## New drum brake lining gigant 146 for wheel brake 3010

Start of production 10´2016

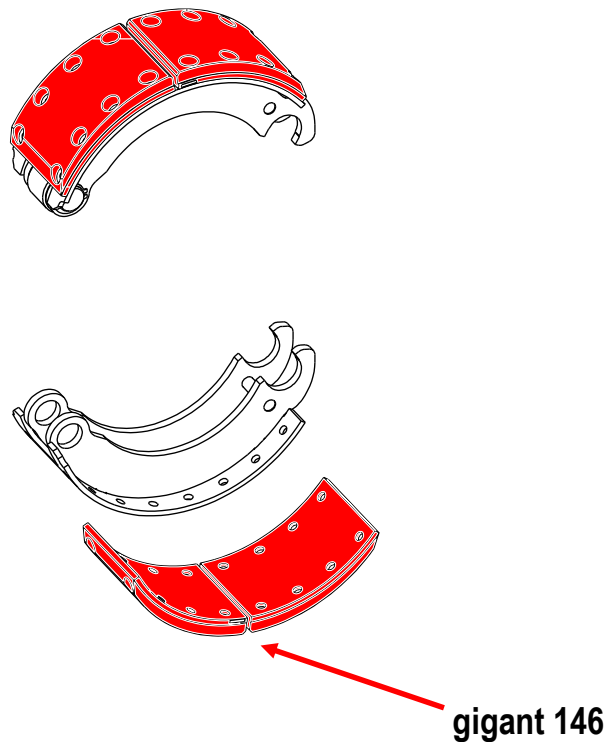
In cooperation with our long-term supplier of friction linings we have developed and validated the gigant brake lining 146. This brake lining has been checked according to ECE R13 for OEM and ECE R90 for OES.

- Checked according ECE R13 and ECE R90
- Stabil friction coefficient behaviour of the brake lining for the complete lifetime.
- Optimised wear behaviour based on temperature, pressure and speed.
- Environmental at the actual level (according ECO-5 level).

Please take care, that due to the new brake lining for the original equipment, an update of the vehicle specified accreditation is necessary.
